| **Subject:** | Fw: 2019-06-18 # Tract 50666 # Request for Storm Drain Amendment |

SAWAYA ENGINEERING CONSULTANTS, INC.
*CIVIL ENGINEERING • LAND PLANNING • SURVEYING*

Re: **Request to use Forestall Canyon to convey off-site storm water in lieu of the proposed 60 inch Reinforced Concrete Pipe.**

# EXHIBIT "A"
# TRACT 50666
# PRE-DEVELOPMENT
# EXISTING STORM DRAIN

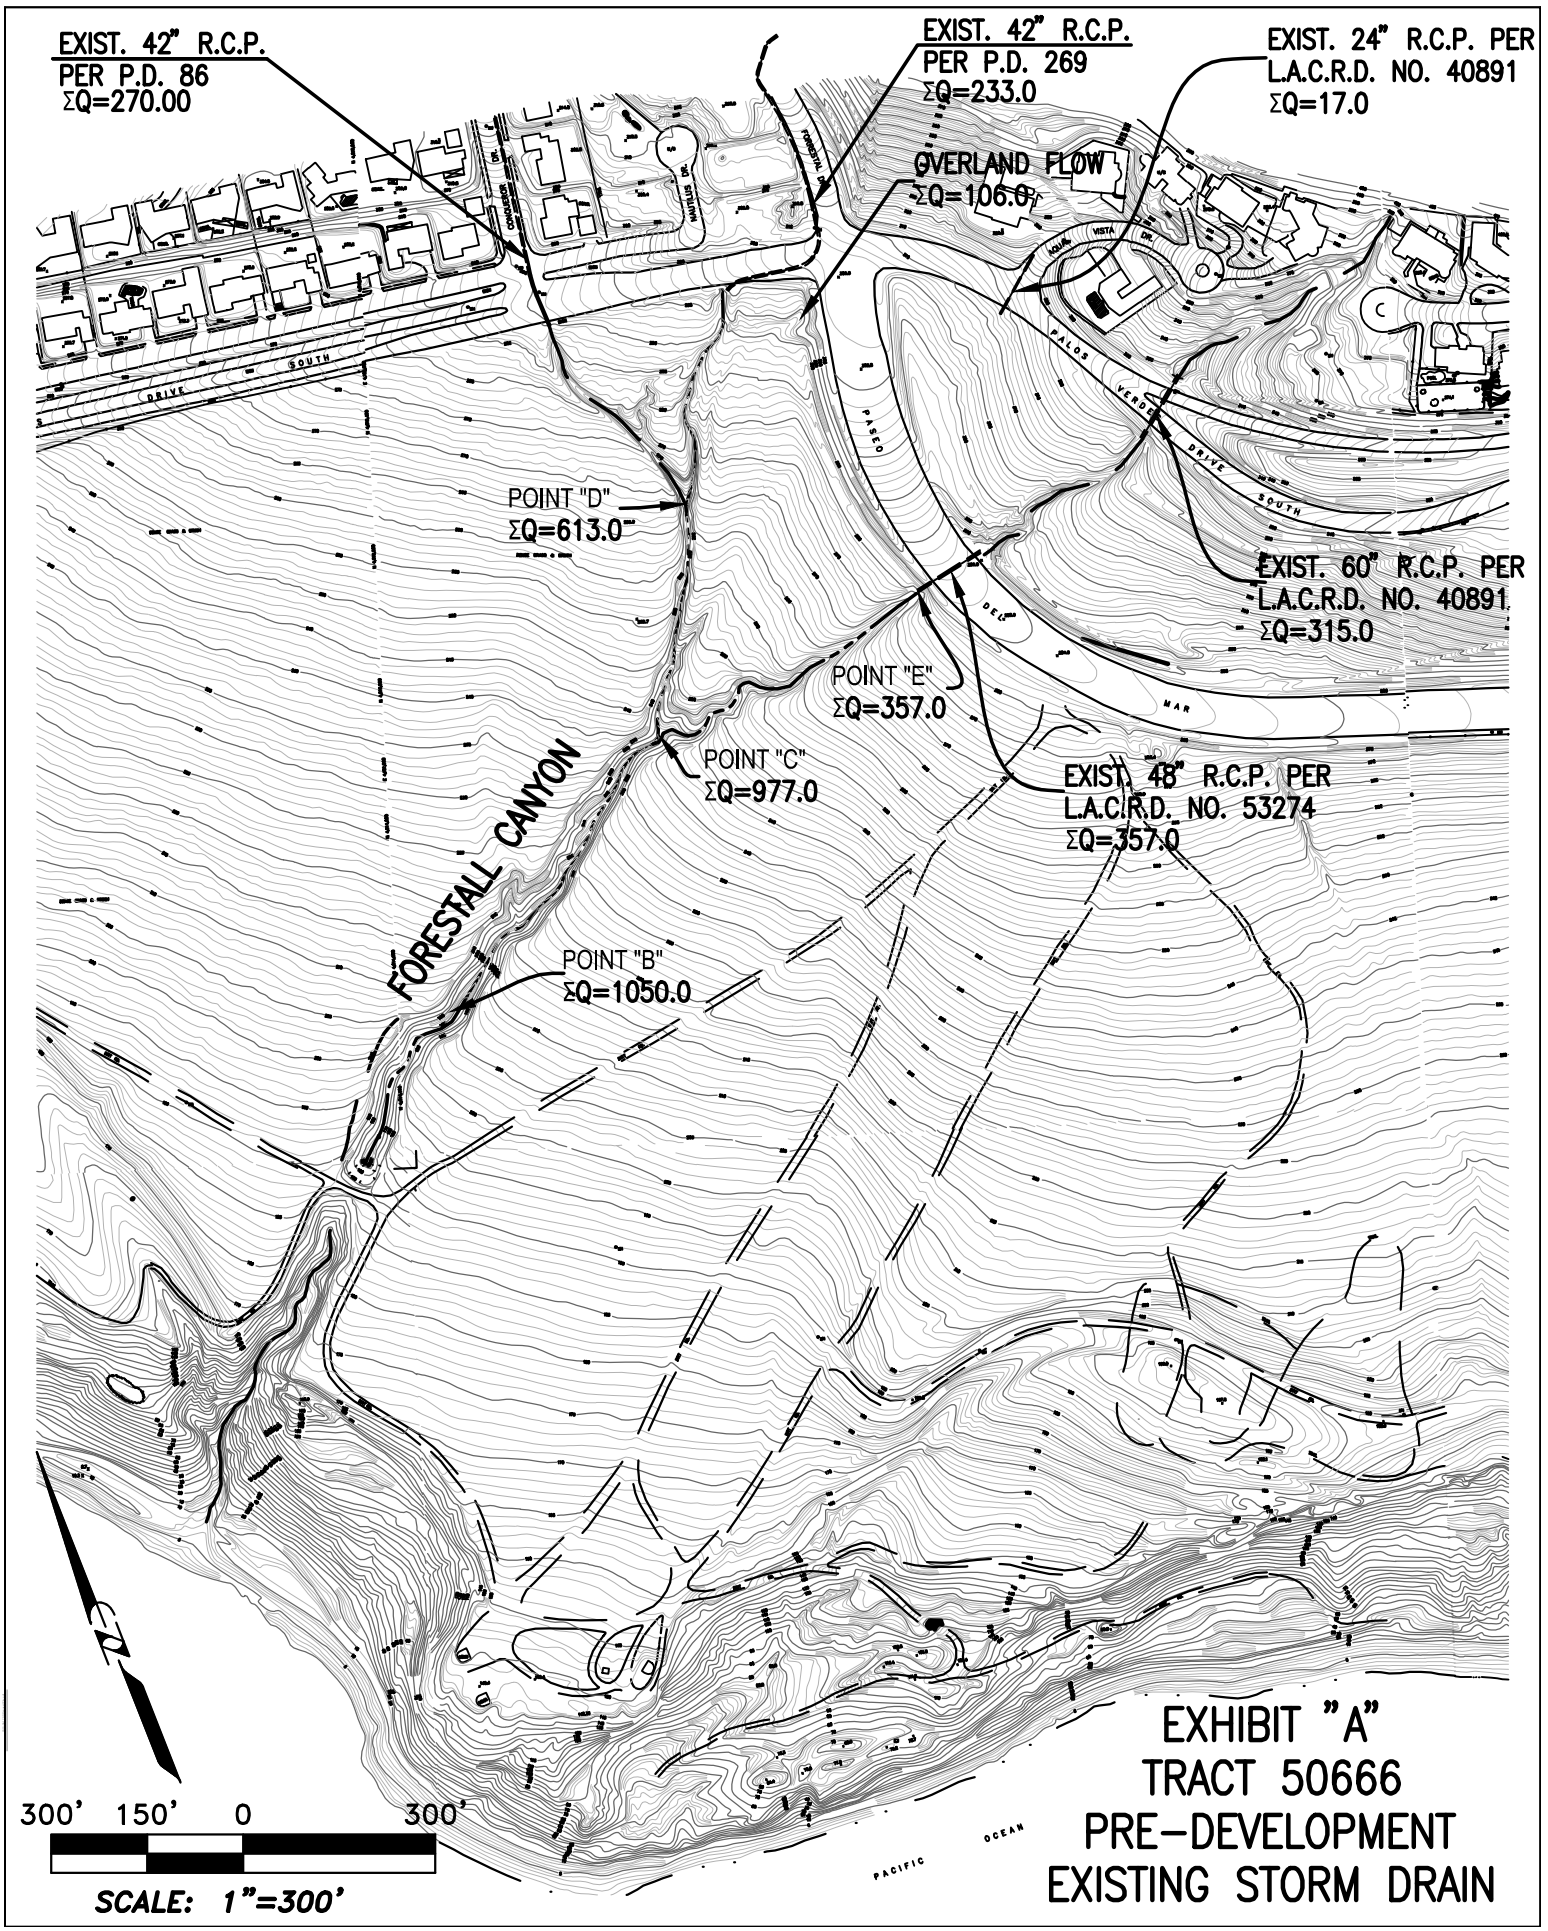
Three different storm drain systems were constructed to outlet to Forestall Canyon to ultimately convey the off-site flow to the ocean. Historically, the flow in Forestall Canyon ranged from 613.0 cfs at Point "D" to 1050.0 cfs. At Point "B" (see Exhibit A).

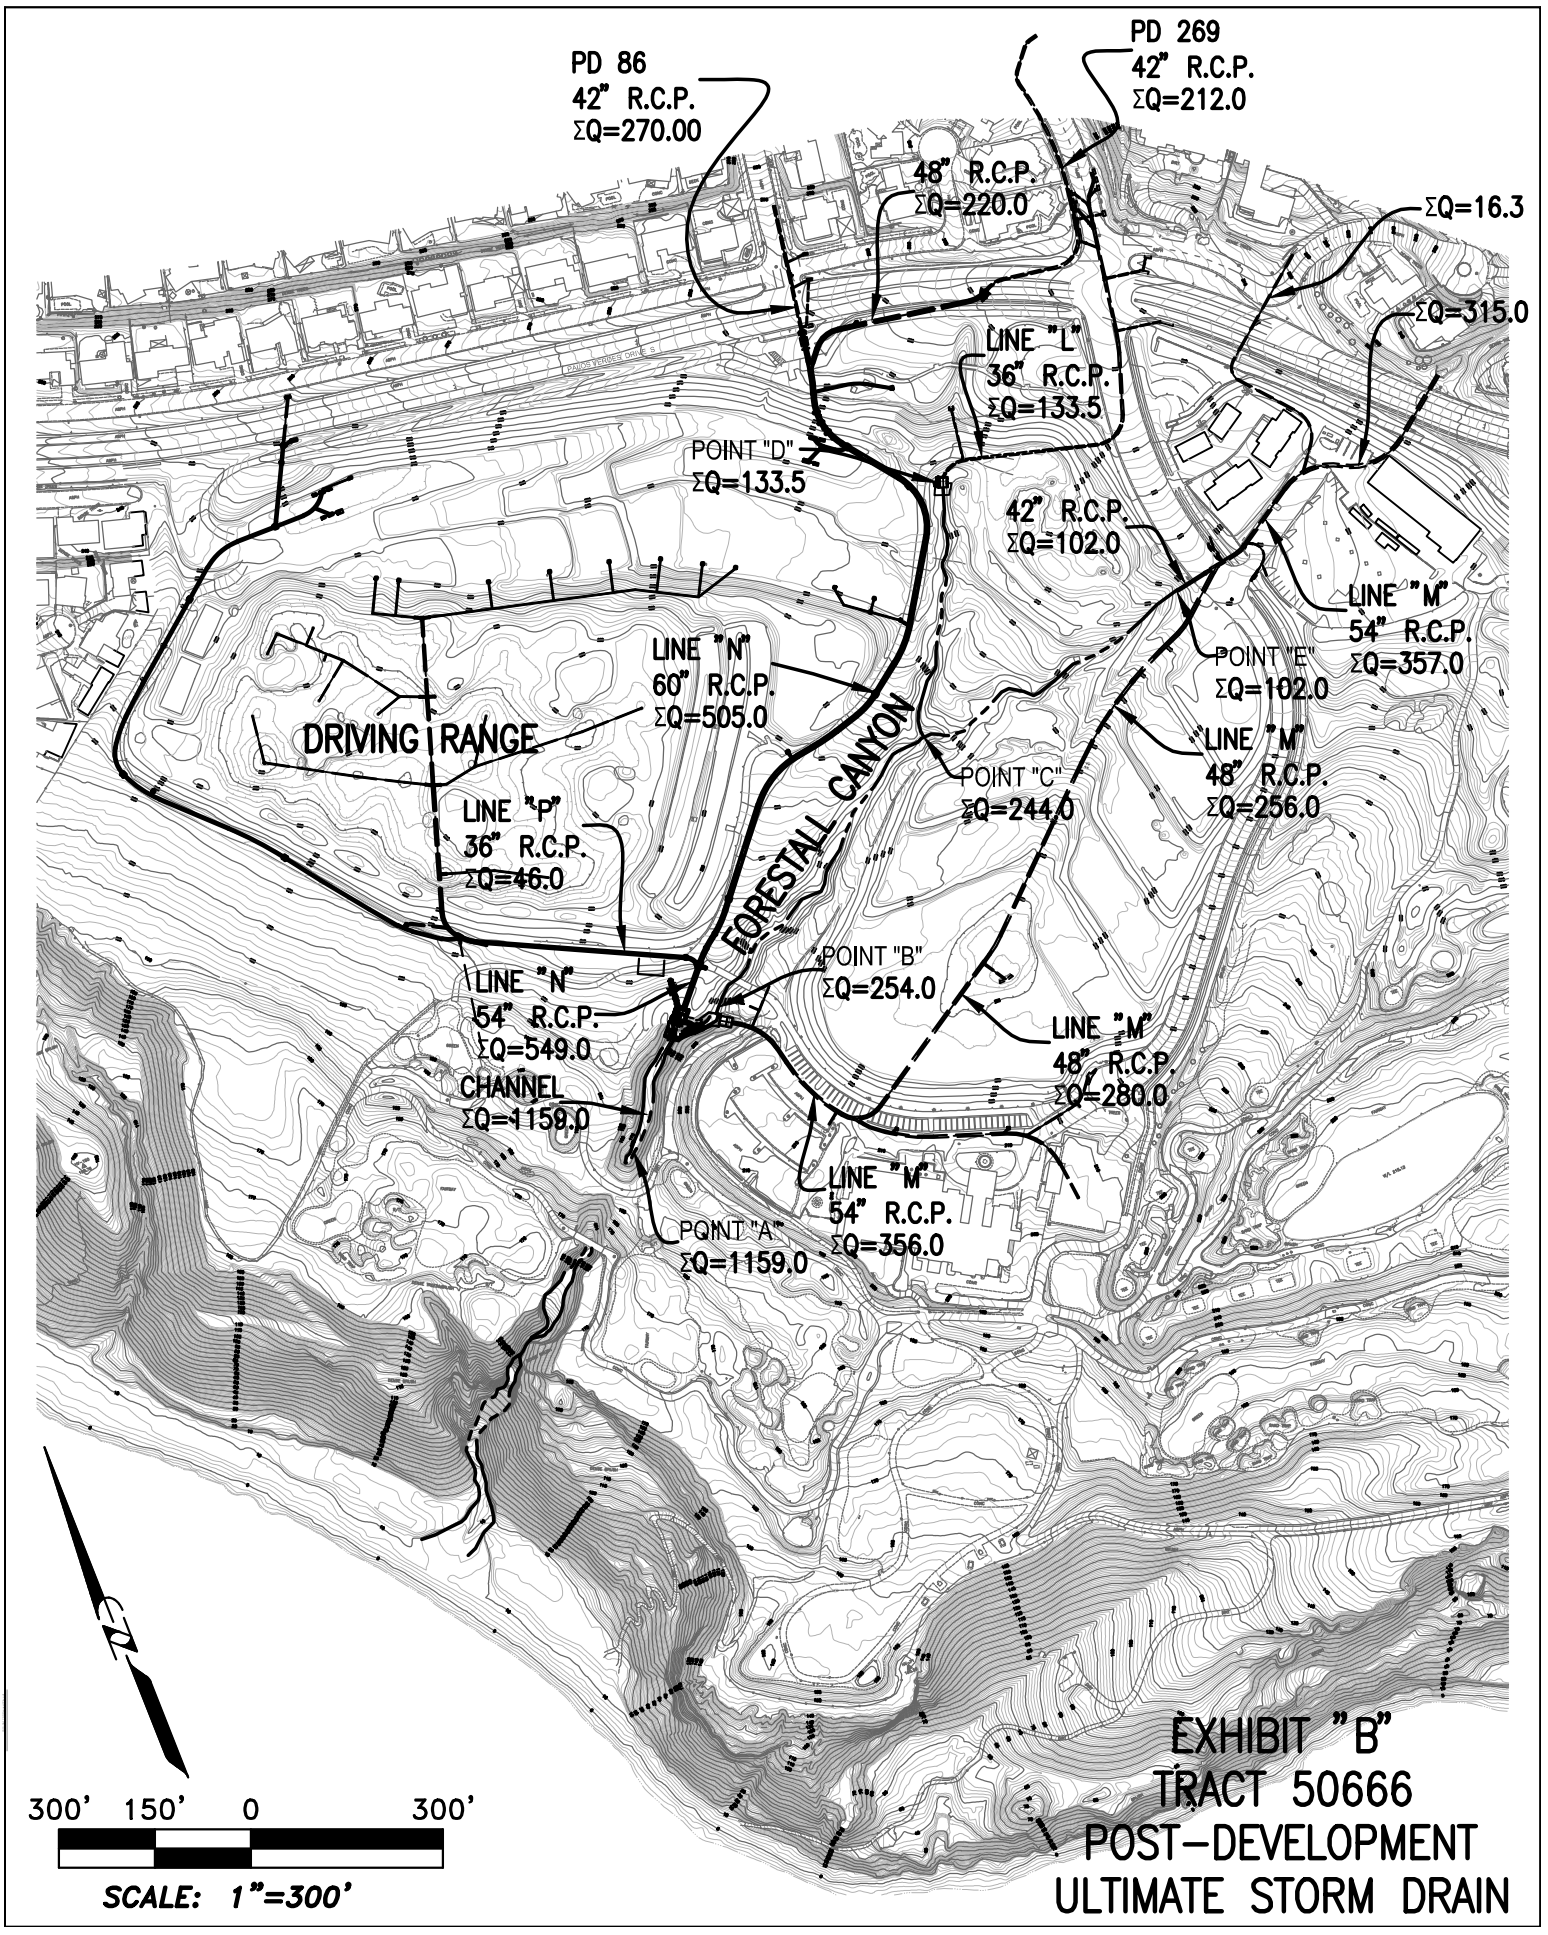
The Drainage Concept of the development as proposed in 2000 and shown on Exhibit "B" was set to reduce / minimize the risk of flooding of the proposed lots from Forestall Canyon. As a result, the flow within Forestall canyon was reduced from 1050.0 cfs at Point "B" to approximately 254.0 cfs. The balance of approximately 800 cfs was to be conveyed back to Forestall Canyon downstream of the proposed lots at Point "B" via a storm drain piping system.

The storm drain systems per PD 86 and PD 269 were existent prior to the development. Line "L" and Line "M" were constructed in 2004 and have been in operation since. The only remaining storm drain lines to be constructed for the development to satisfy the approved Drainage Concept are Line "N" and line "P" (See Exhibit "B").

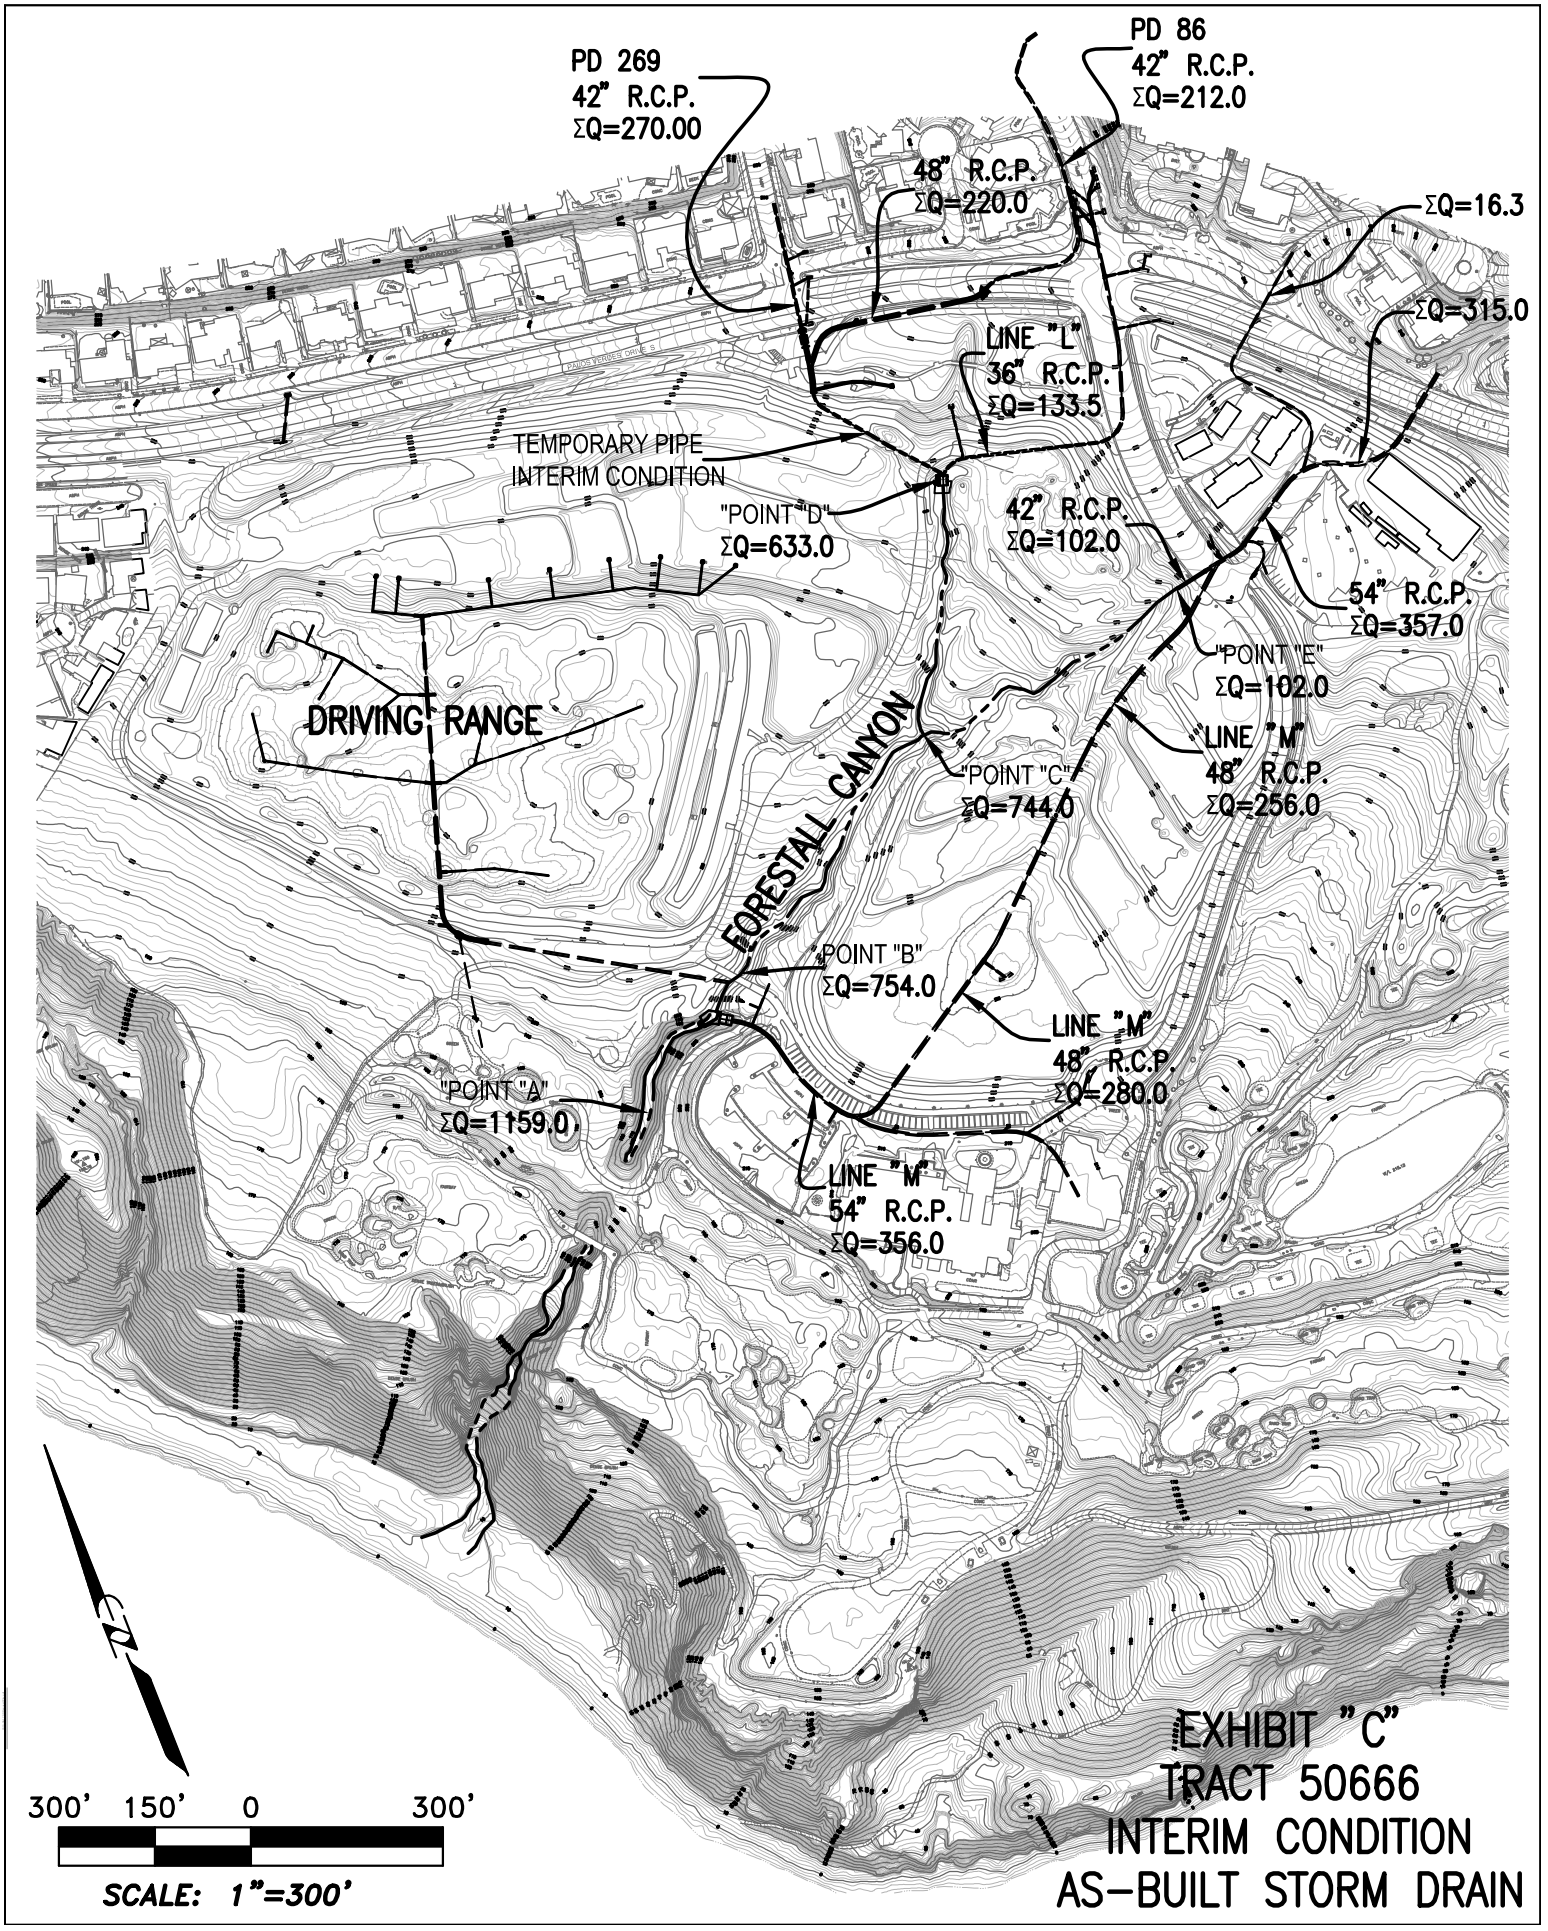
In the interim and until the ultimate drainage system is completed, a temporary pipe was constructed in 2005 to convey the flow of PD 86 and PD 269 back to Forestall Canyon (See Exhibit "C"). Since 2005, (approximately 15 years), the flow within Forestall Canyon between Point "D" and Point "B" has ranged from 633.0 cfs to 754.0 cfs, which is below the historical / predevelopment flow of 1050.0 cfs.
